Offshore Wind Farm

Outline Construction Traffic Management Plan (Clean)

Document Reference: 7.16
Volume: 7
Date: April 2025
Revision: 3

Drawing 104560-MMD-00-XX-DR-CE-1061_Rev01

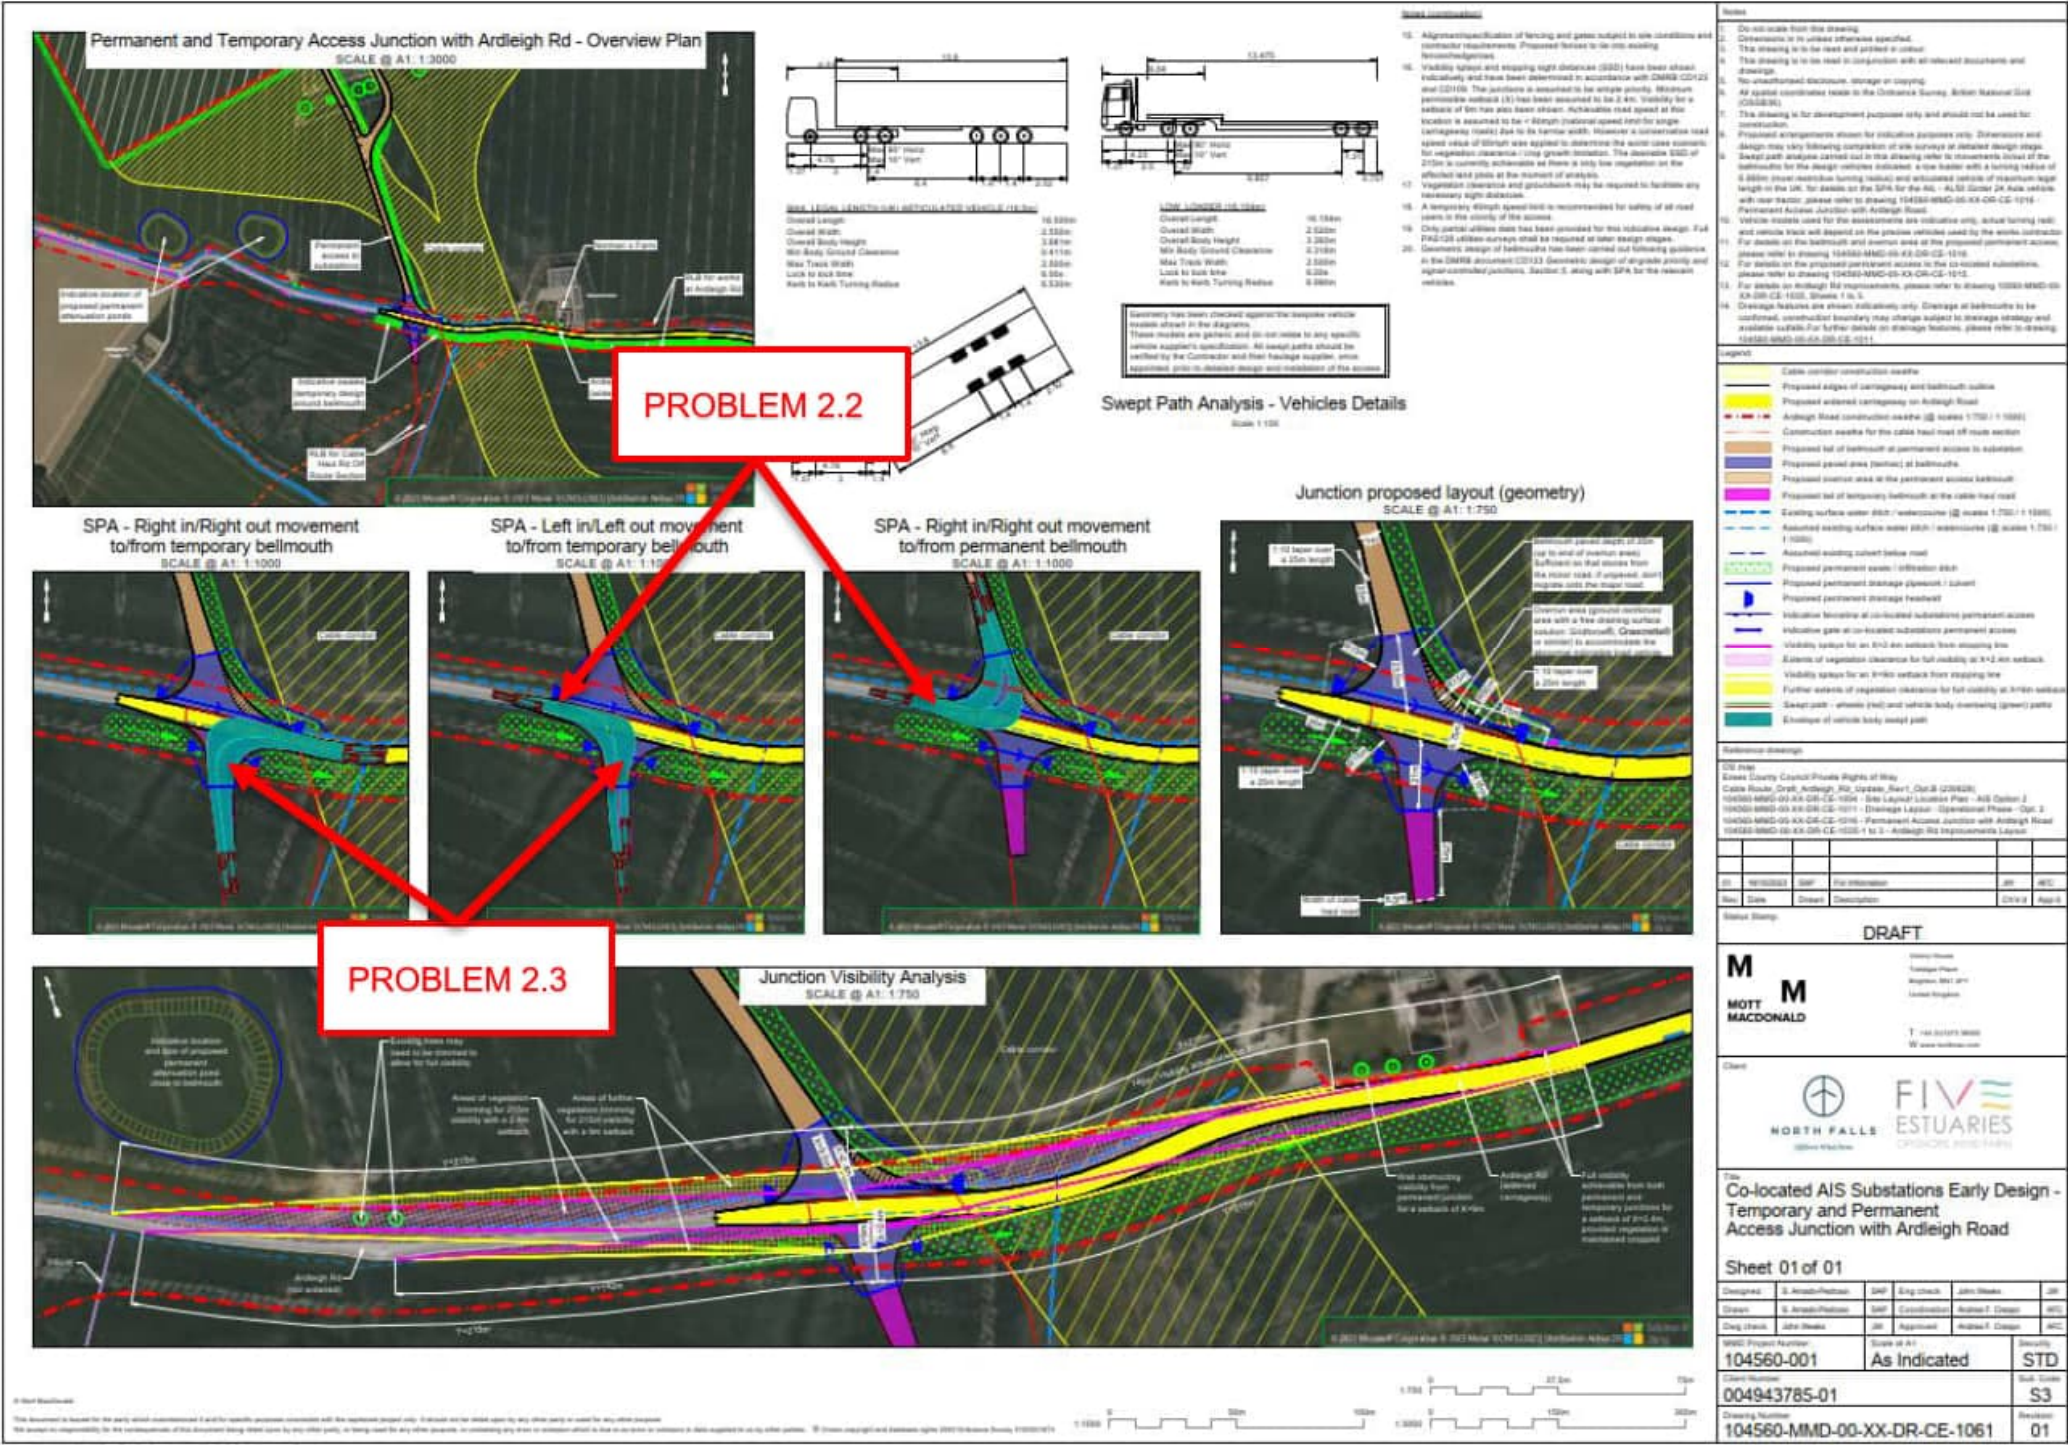
Drawing 104560-MMD-00-XX-DR-CE-1061_Rev01						
2.1	Location: Site Access (Temporary Access Junction with Ardleigh Rd) Summary: Overhead cables may lead to damage to infrastructure, vehicles and occupants. Onsite observations noted the presence of overhead cables that cross Ardleigh Road in various locations in the vicinity of the proposed development. The vertical alignment of proposed HGV access movements may lead to damage to infrastructure or damage to vehicles and injury to occupants.	It is recommended that the vertical assessment is carried out for the appropriate vehicle types to ensure no conflict remains.	● RSA problem and recommendation agreed. ● This matter will be appraised further as an integral part of the detailed design process, when full PAS128 utilities surveys are to be obtained, and drawings detailing diversion or undergrounding (and/or further measures required) of utilities in the vicinity of the proposed access junction and crossing will be developed to take due account of the safety problem and the aligned recommendation. ● A wider utility diversion / undergrounding assessment would need to be carried out by the third party in charge of the Ardleigh Rd improvement works design at the scheme detailed design stage, when full PAS128 utilities surveys shall be completed. Coordination between Mott MacDonald and that third party may be required. ● Notes 9 and 19 in drawing 104560-MMD-00-XX-DR-CE-1061_Rev01 are intended to account for this matter: ● Note 9. «Proposed arrangements shown for indicative purposes only. Dimensions and design may vary following completion of site surveys at detailed design stage». ● Note 19. «Only partial utilities data has been provided for this indicative design. Full PAS128 utilities surveys shall be required at later design stages».	TBC	TBC	This matter will be appraised further as an integral part of the detailed design process, when full PAS128 utilities surveys are to be obtained, and drawings detailing diversion or undergrounding of utilities in the vicinity of the proposed access junction and crossing will be developed to take due account of the safety problem and the aligned recommendation (TBC).

Drawing 104560-MMD-00-XX-DR-CE-1032-1_Rev02

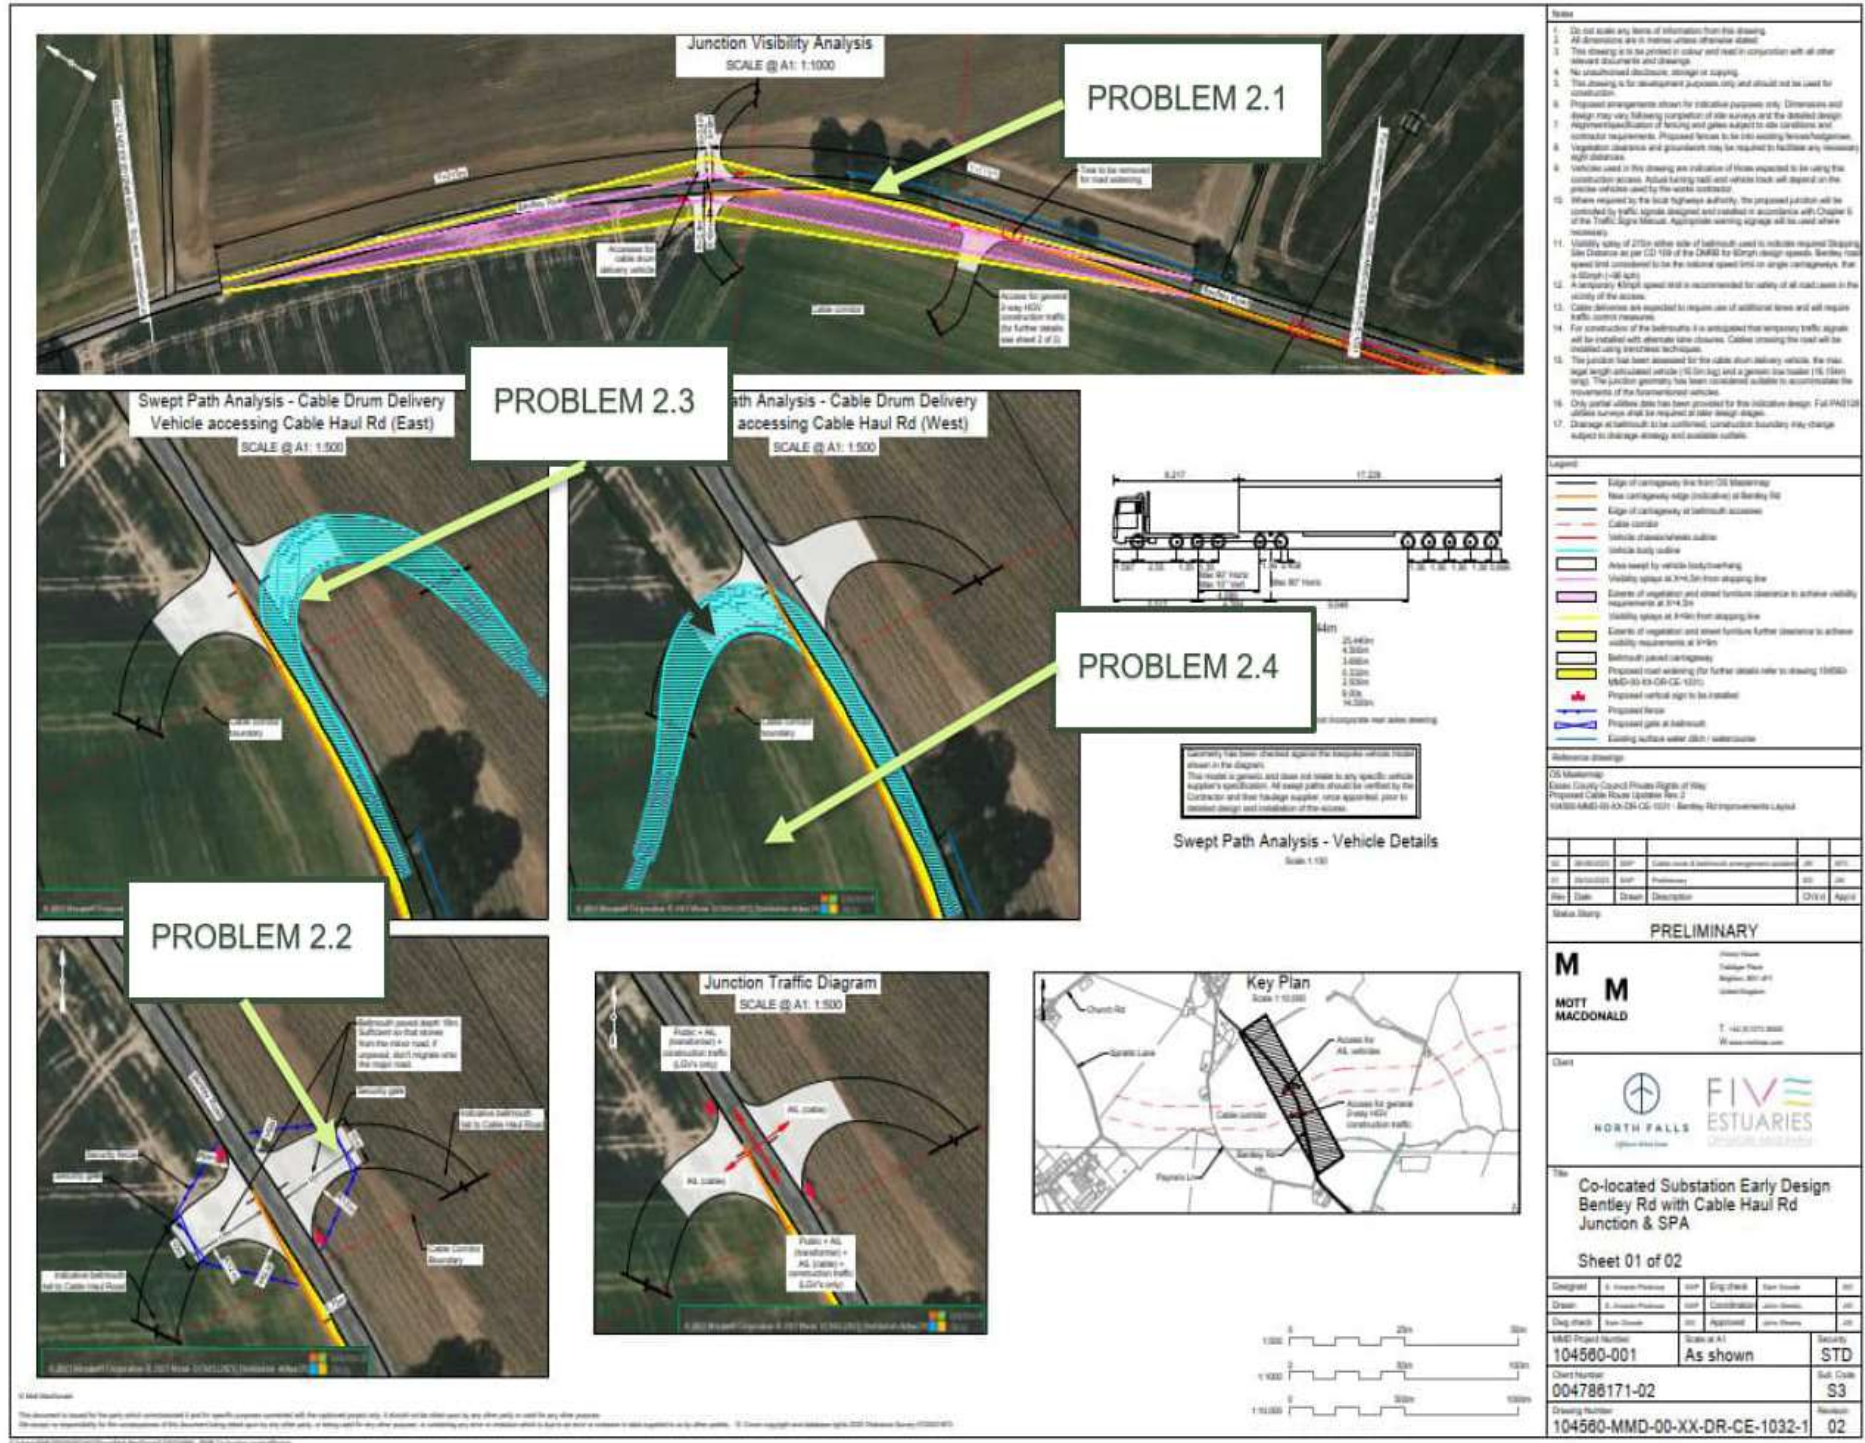
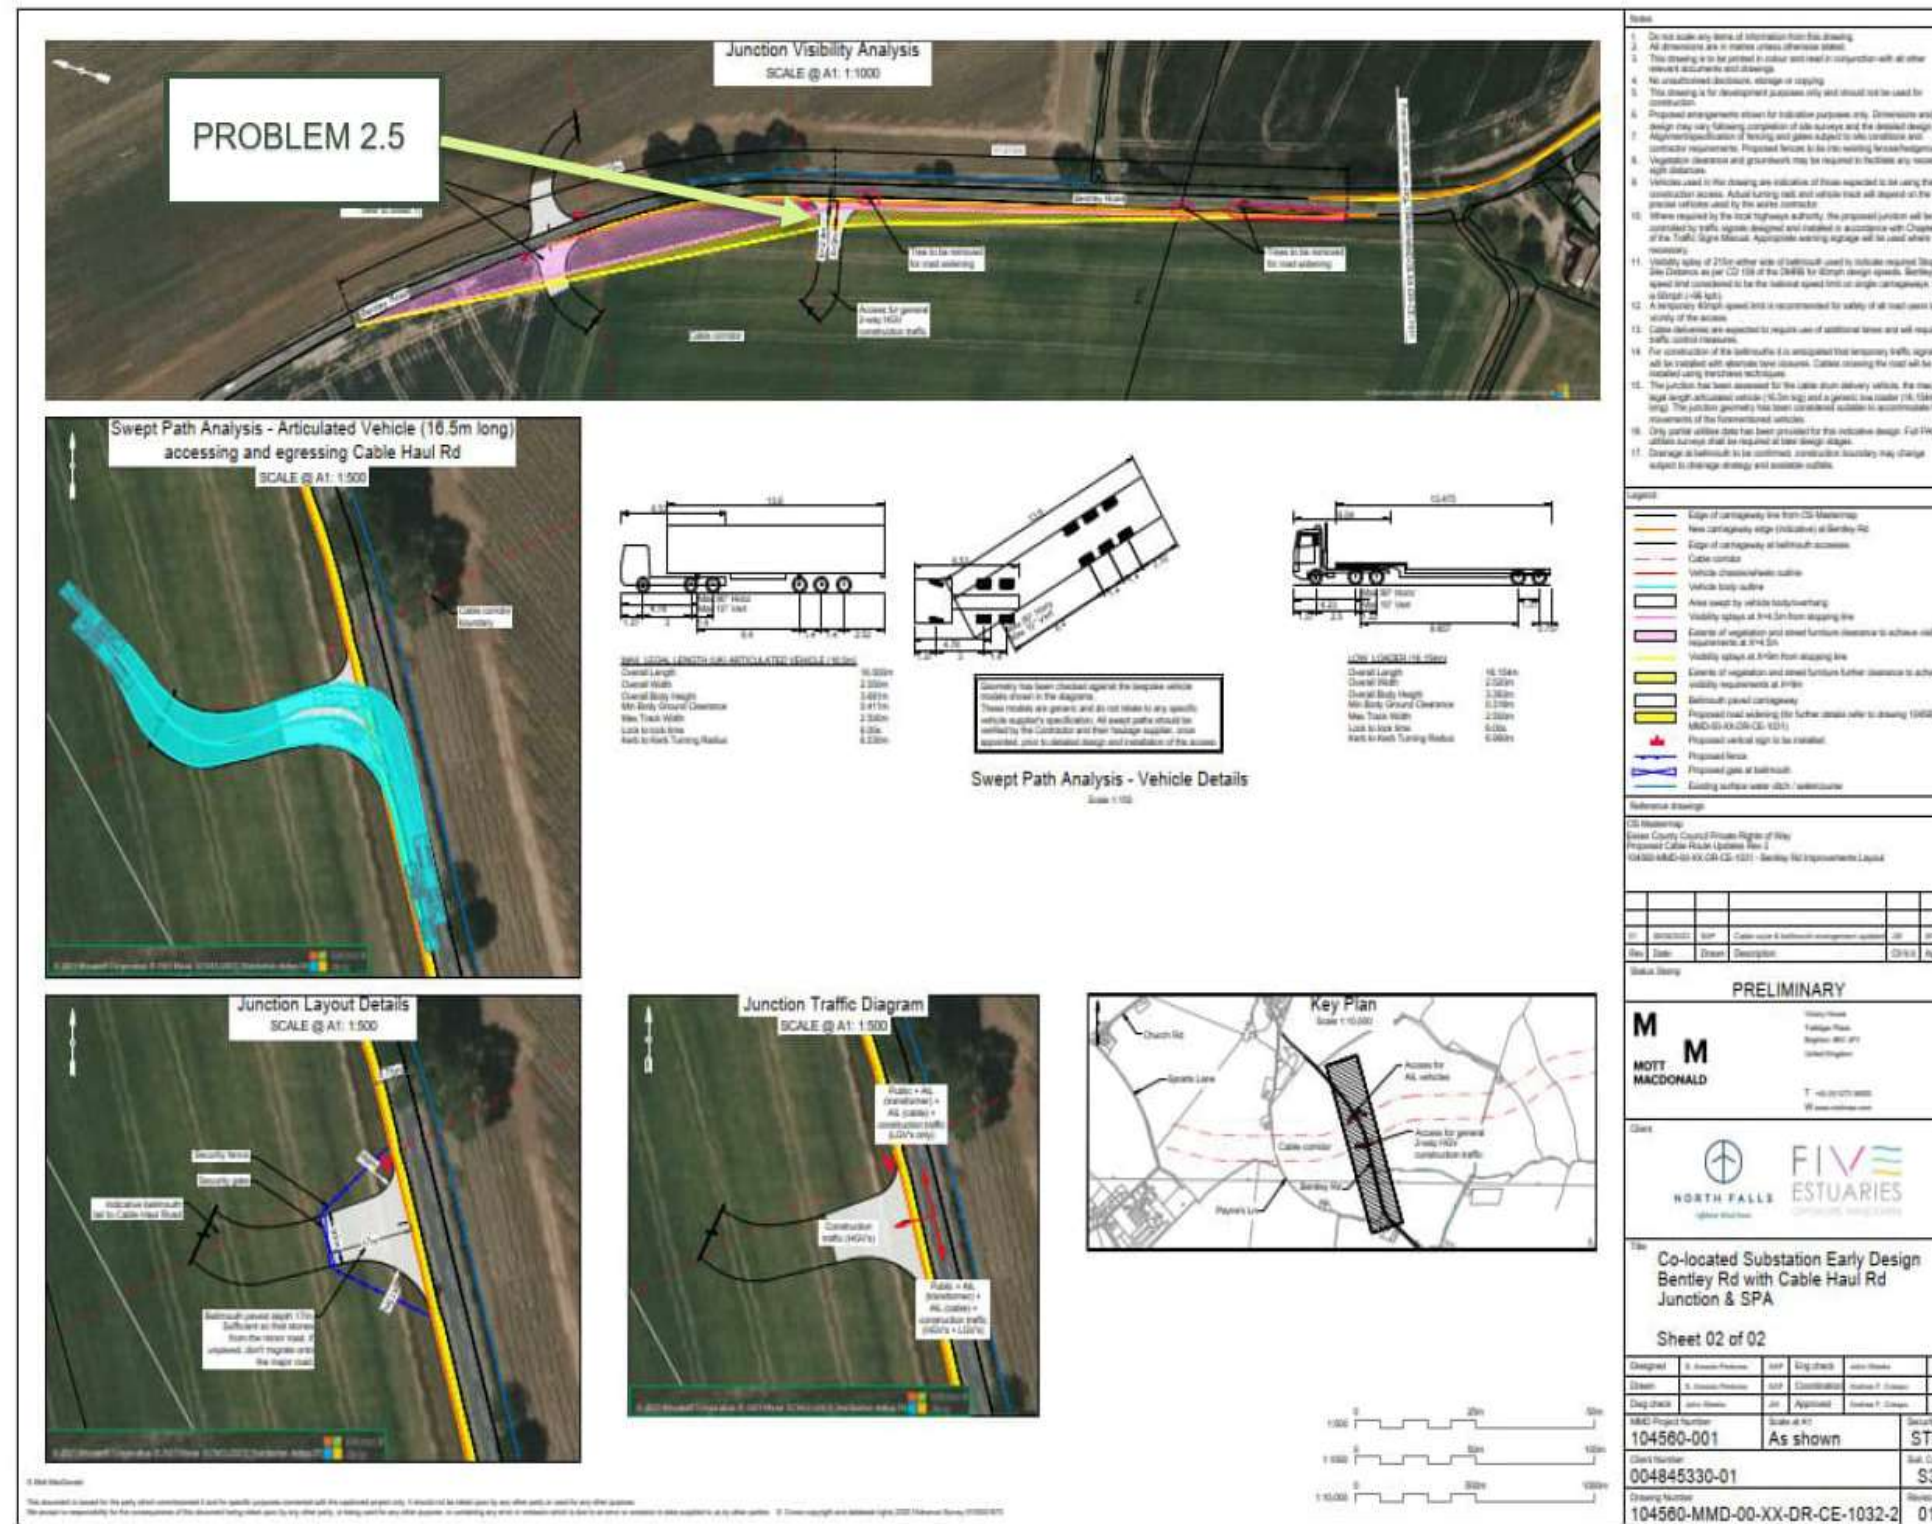
Drawing 104560-MMD-00-XX-DR-CE-1032-1_Rev02						
2.1	Location: Site Access (Temporary Access Junction with Bentley Rd). Refer to Appendix B. Summary: At a 9m setback, existing trees may obscure the visibility splay potentially leading to side swipe type collisions. Onsite observations noted that the presence of existing vegetation may constitute an obstruction to the junction visibility. Obstruction to visibility splays may lead to injudicious vehicle movements at the proposed junction leading to side swipe collisions between vehicles.	It is recommended that the trees be cut back and maintained as such that it does not pose an obstruction to the visibility splays.	● RSA problem and recommendation acknowledged but not agreed since it is not considered that these trees have an impact on the visibility clearance areas. The visibility splay with a 9m setback on the eastern side of Bentley Rd (northern side of Bentley Rd on drawing 104560-MMD-00-XX-DR-CE-1032-1) only captures a small area of road verge west of these existing trees, to run across the road to the other verge side west of Bentley Rd (South of Bentley Rd in drawing 104560-MMD-00-XX-DR-CE-1032-1). Cutting back or trimming the trees will not produce any changes to visibility. Trees are located on the southeast of the road and will cast shadow during most part of the day unless they are totally cut. ● In drawing 104560-MMD-00-XX-DR-CE-1031-3 for the same scheme (refer to Appendix C in this document), it is indicated the trimming of these existing trees to facilitate passage of vehicles, which will also help with general visibility. ● No designer action proposed.	TBC	TBC	No action (TBC).

Drawing 104560-MMD-00-XX-DR-CE-1032-2_Rev01						
2.5	Location: Proposed site access. Refer to Appendix B. Summary: The level difference between the carriageway and site could result in loss of control or side swipe type collisions. Onsite observations found that there was a difference in levels between the existing carriageway and the new access. An excessive gradient may create difficulty for large construction vehicles wishing to access Lodge Lane and may in turn lead to a lack of surface friction and slow egress movements potentially creating shunt / side swipe type collisions between egressing construction vehicles and vehicles travelling on Bentley Road.	It is recommended that the existing gradient be amended to an appropriate level for the restart movements of large vehicles accessing Bentley Road from the proposed site	- RSA problem and recommendation agreed. - This matter will be appraised further as an integral part of the detailed design process and drawings developed to take due account of the safety problem and the aligned recommendation.	TBC	TBC	This matter will be appraised further as an integral part of the detailed design process and drawings developed to take due account of the safety problem and the aligned recommendation. (TBC)

Ref.	RSA Problem	RSA Recommendation	Design Organisation Response	Audit Team Supplementary Comment	Client / Project Sponsor Comment	Agreed RSA action
			envelope, fits within the bellmouth outlines. The chassis envelope line will be brought forward in the drawing for clarity. - Also please note that vehicle models used to perform the SPA are conservative and representing a worst case scenario. We can conclude that if the vehicle chassis swept path fits within the carriageway limits with these conservative vehicle models (as it does), room is to be sufficient in reality. - Note 9 in drawing 104560-MMD-00-XX-DR-CE-1032-1_Rev02 («Vehicles used in this drawing are indicative of those expected to be using this construction access. Actual turning radii and vehicle track will depend on the precise vehicles used by the works contractor») and disclaimer shown in Vehicle Details («This model is generic and do not relate to any specific vehicle supplier's specification. All swept paths should be verified by the Contractor and their haulage supplier, once appointed, prior to detailed design and installation of the access») were included as caveats in relation to this matter.
